LYNDHURST GARDENS

GENERAL ARRANGEMENT

PROJECT NO. 639/14	DRAWING NUMBER: GA001	REVISION: P03
-----------------------	--------------------------	------------------

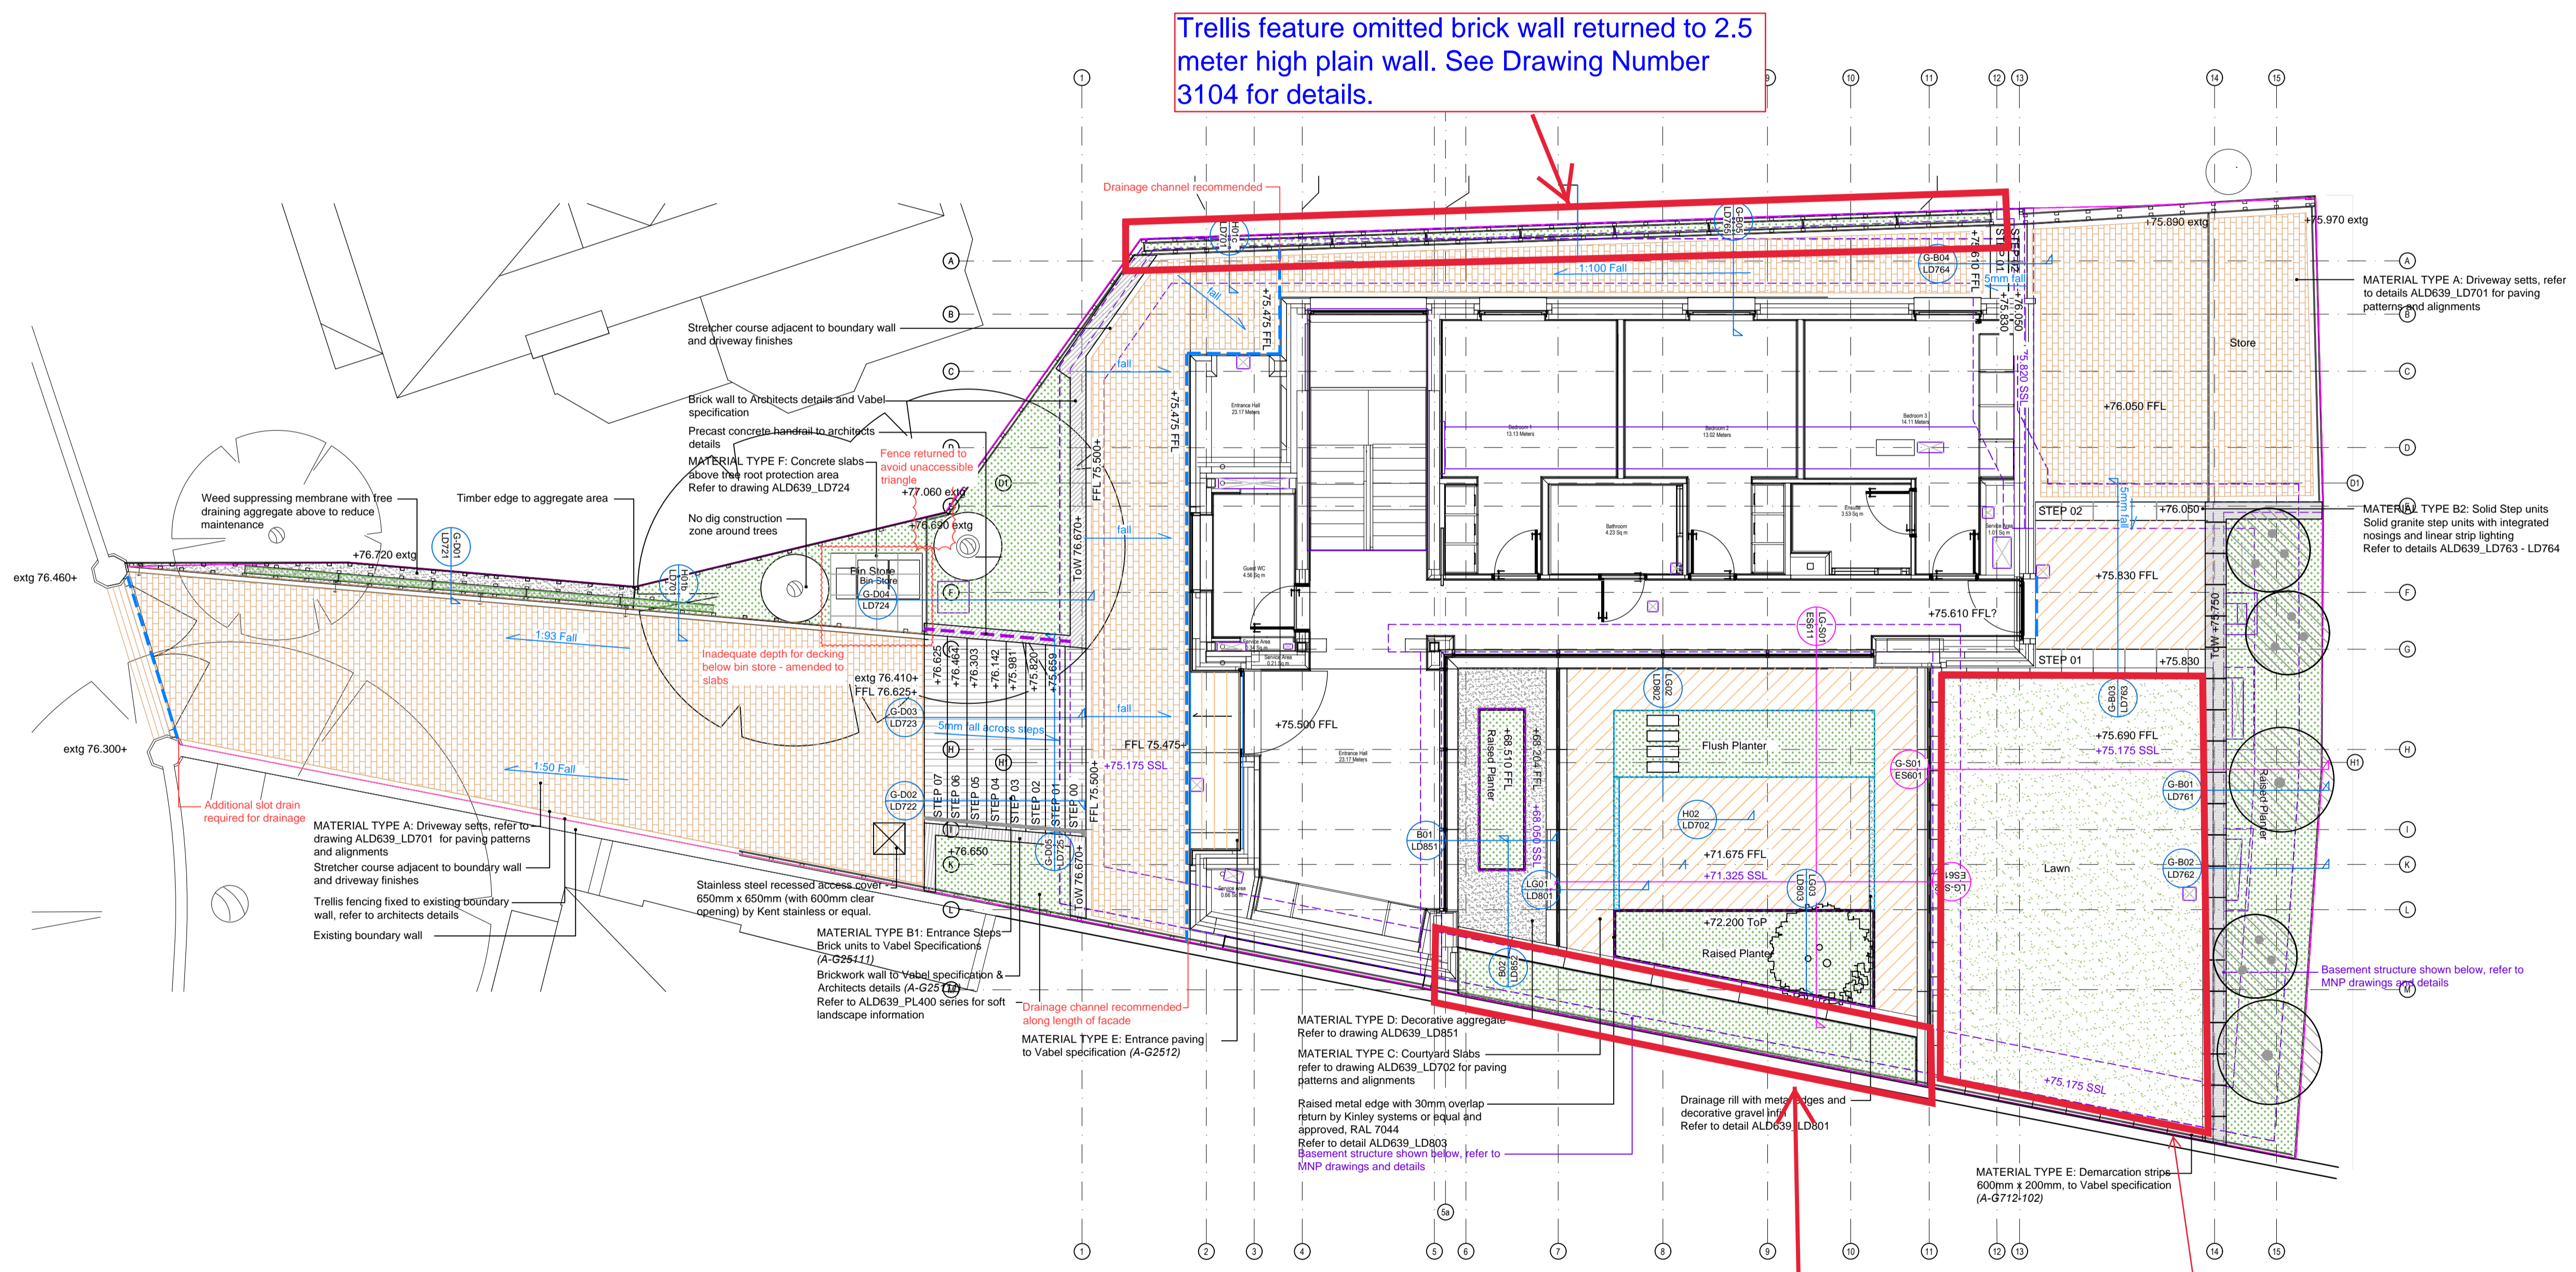
Trellis feature omitted brick wall returned to 2.5 meter high plain wall. See Drawing Number 3104 for details.

Area of planting to be omitted and changed to paving to allow for access for maintenance to the site boundary. Glass balustrade to be introduced to provide guarding along the light well edge to make the area safe for working. See Drawing Number 3104 for details.

Grass lawn replaced with artificial turf due to maintenance concerns.
